Serial: RNP-RA/08-0124

H. B. ROBINSON STEAM ELECTRIC PLANT, UNIT NO. 2
DOCKET NO. 50-261/LICENSE NO. DPR-23

RESPONSE TO REQUEST FOR ADDITIONAL INFORMATION PERTAINING TO NRC GENERIC LETTER 2004-02, "POTENTIAL IMPACT OF DEBRIS BLOCKAGE ON EMERGENCY RECIRCULATION DURING DESIGN BASIS ACCIDENTS AT PRESSURIZED-WATER REACTORS"

RESPONSE TO REQUEST FOR ADDITIONAL INFORMATON ON THE SUPPLEMENTAL RESPONSE TO NRC GENERIC LETTER 2004-02, "POTENTIAL IMPACT OF DEBRIS BLOCKAGE ON EMERGENCY RECIRCULATION DURING DESIGN BASIS ACCIDENTS AT PRESSURIZED-WATER REACTORS"

Figure 1
Arrangement of the 1 by 4 Strainer Array in the Test Tank

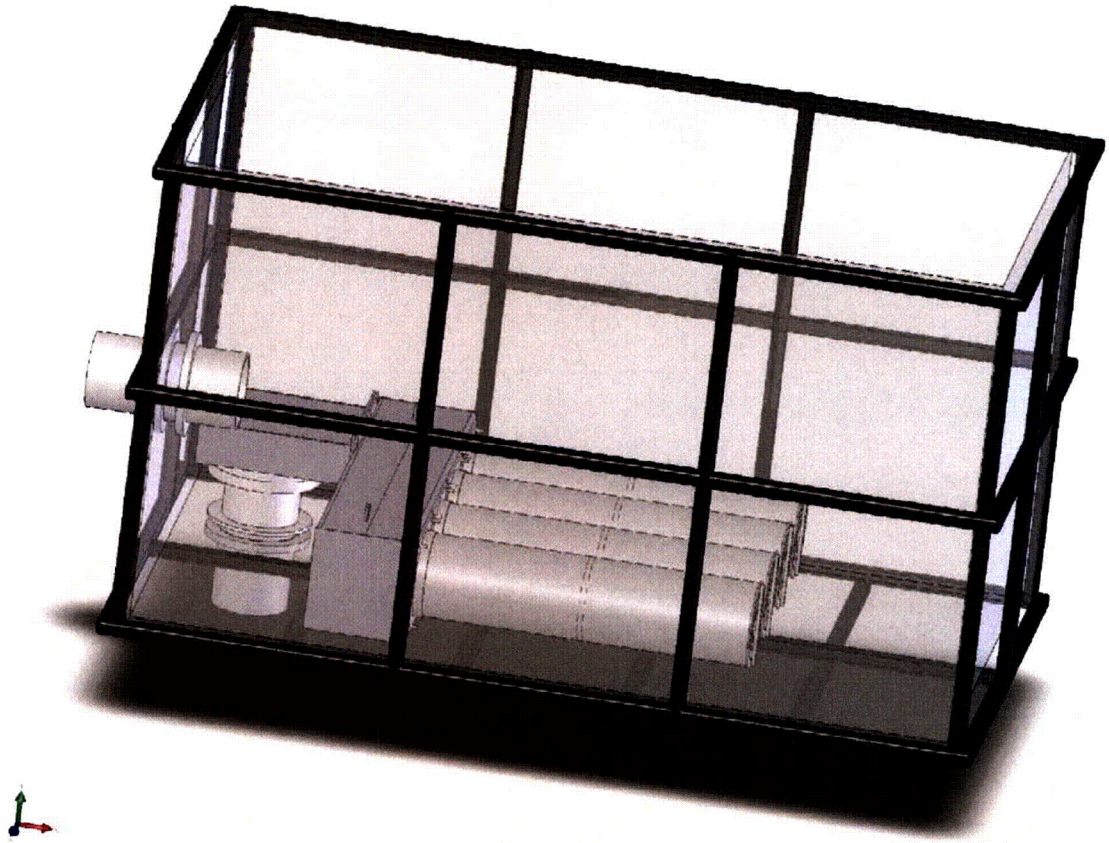
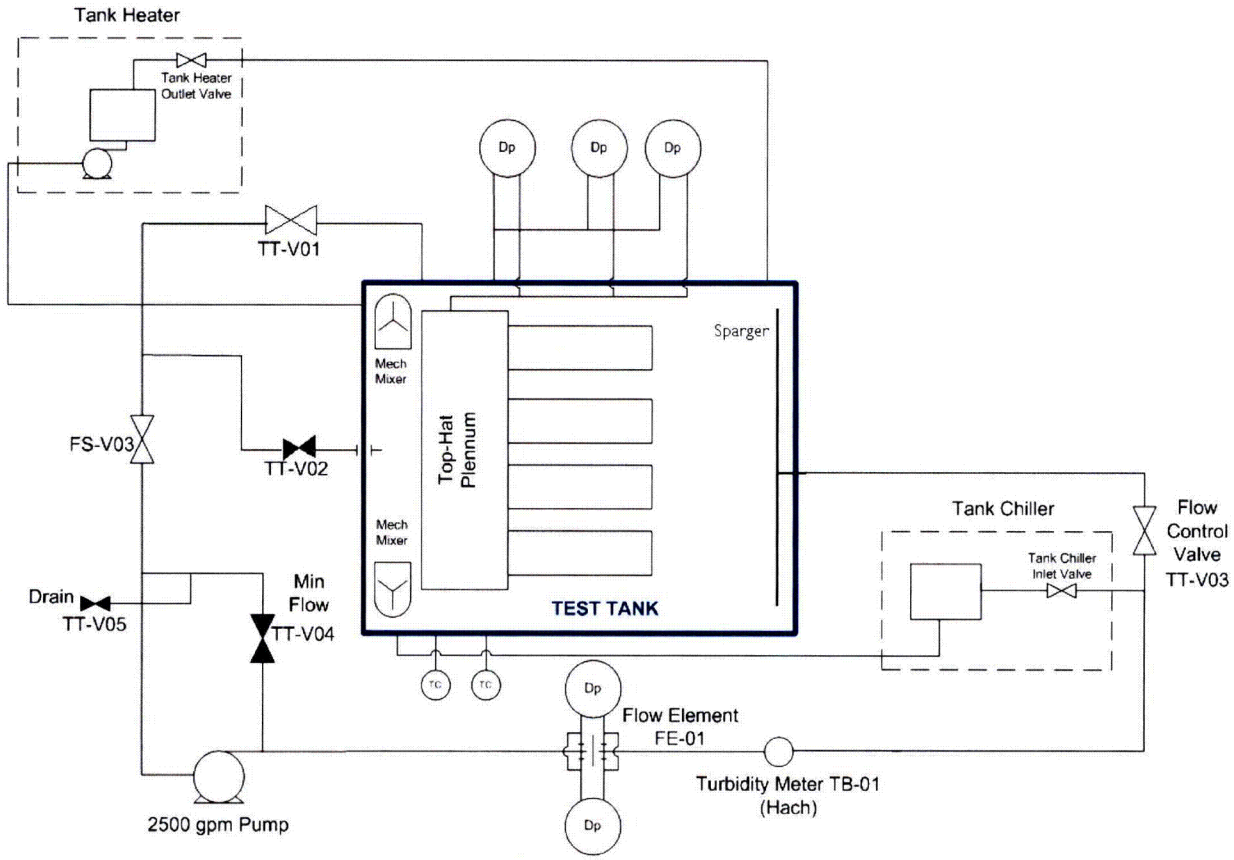
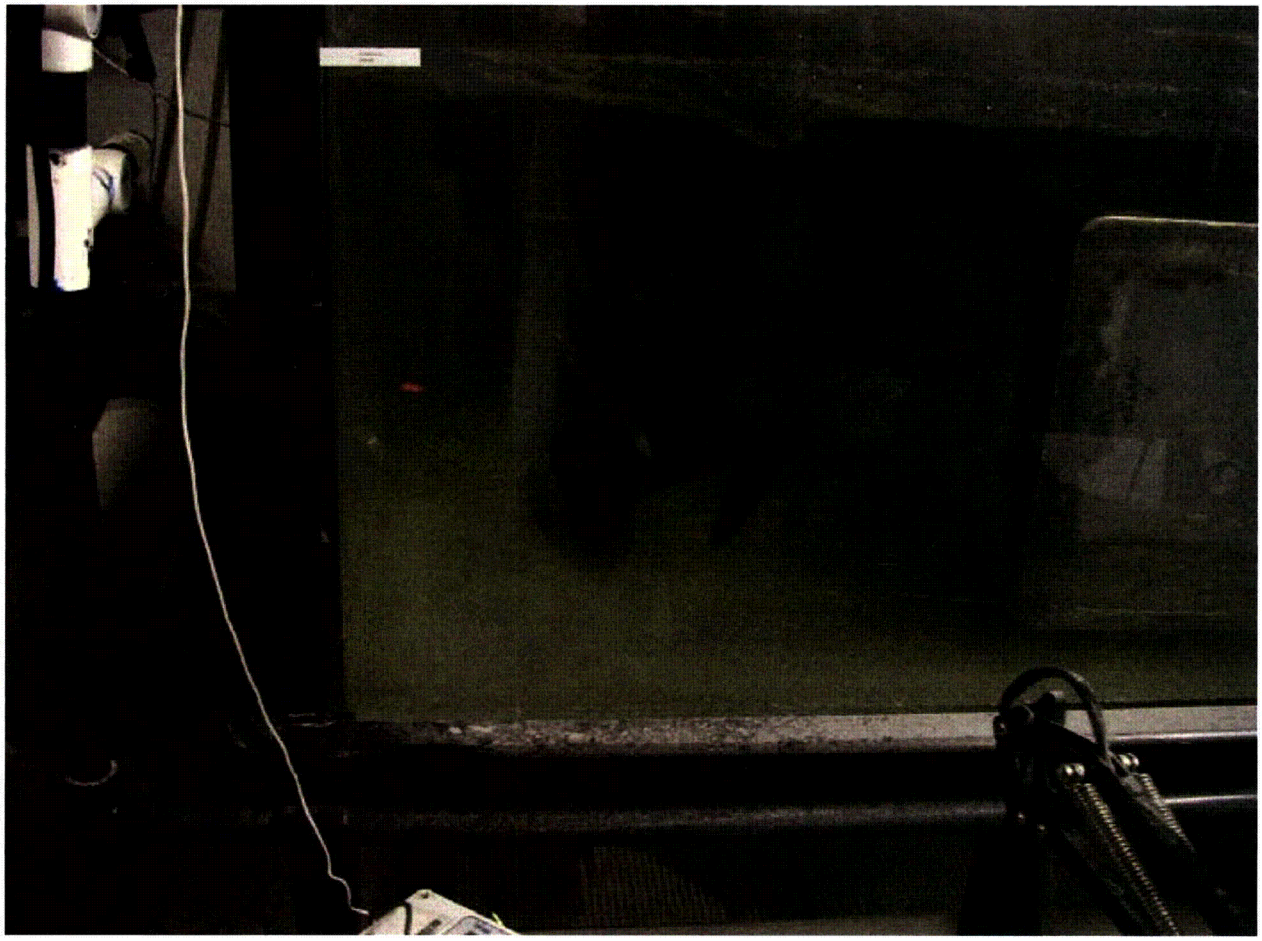
Please provide documentation of how much debris, and to the extent possible, what types of debris, settled during testing.

The 1 by 4 screen array prototype nearly filled the bottom of the test tank (reference Figure 1). The spacing between the screen and the tank side walls was approximately 6 and 5/8 inches, which approximates the edge-to-edge distance between adjacent strainer groups as installed in the plant. The spacing between the screen end and the sparger was approximately 12 inches. The vast majority of debris that did not settle on the screens settled within approximately 12 inches of the screen. The sparger and manual stirs kept very little debris from settling between the sparger and the tank wall. Mechanical mixers installed behind the plenum allowed only minimal debris to settle between the plenum and the tank wall. The test reports did not record the volume of debris that settled remote from the screens (i.e., behind the sparger and plenum). As seen in Figures 3 and 4, the amount of debris that settled in these remote areas was not significant when compared to the overall quantity of debris added to the test tank. Visual observations confirmed there was no significant accumulation of debris more than a few inches from the screens.

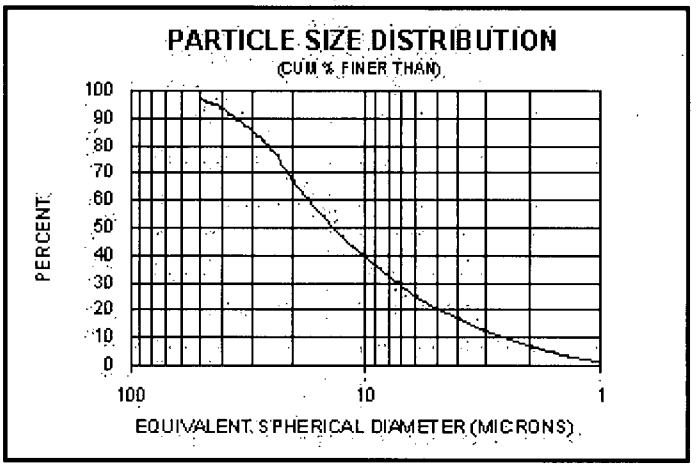
Please provide the size distributions for the particulate debris used during testing. Discuss how these size distributions compare with the guidance in NEI 04-07 and justify any differences with that guidance.

HBRSEP, Unit No. 2, used Si-Co-Sil 53 as a coating surrogate with a size distribution as shown below.

Based on the Si-Co-Sil 53 typical particle size distribution shown above and the approach discussed on Page 3-61 of NEI 04-07 to determine a composite specific surface area (Sv) for

The results of Test 1-1 are plotted below:

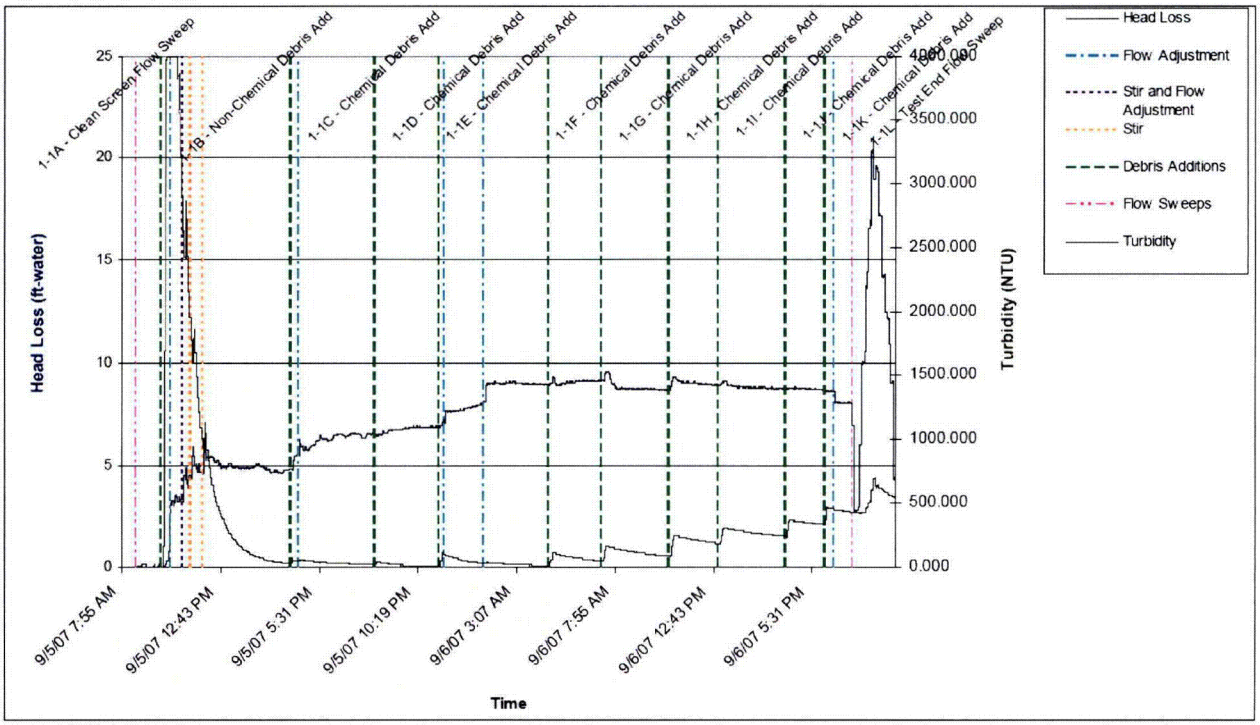
The head loss plot on Page 79 of the March 7, 2008, supplemental response shows little or no effect from the last few chemical precipitate additions to the test loop. There appears to be a debris bed redistribution after chemical addition number 2H, possibly due to calcium silicate dissolution.

Given the small remaining net positive suction head (NPSH) margin for HBRSEP, please indicate whether the head loss plot shown on page 79 of the March 7, 2008, supplemental response provides the maximum integrated head loss test result or only the integrated head loss test data for a specific break scenario. Please provide the other head loss plots if additional head loss tests were performed.

Two tests were completed, identified as Test 1-1 and 2. Test 1-1 added chemicals to a maximum load of 600 pounds compared to 1,500 pounds in Test 2. The plot shown on Page 79 of the submittal is from Test 2 and provides the maximum integrated head loss test result of two tests that were completed for chemical effects head loss determination. The first part of Test 2 was a

confirmatory test of Test 1-1 and had slightly higher non-chemical debris head loss and slightly higher peak chemical head loss over Test 1-1.
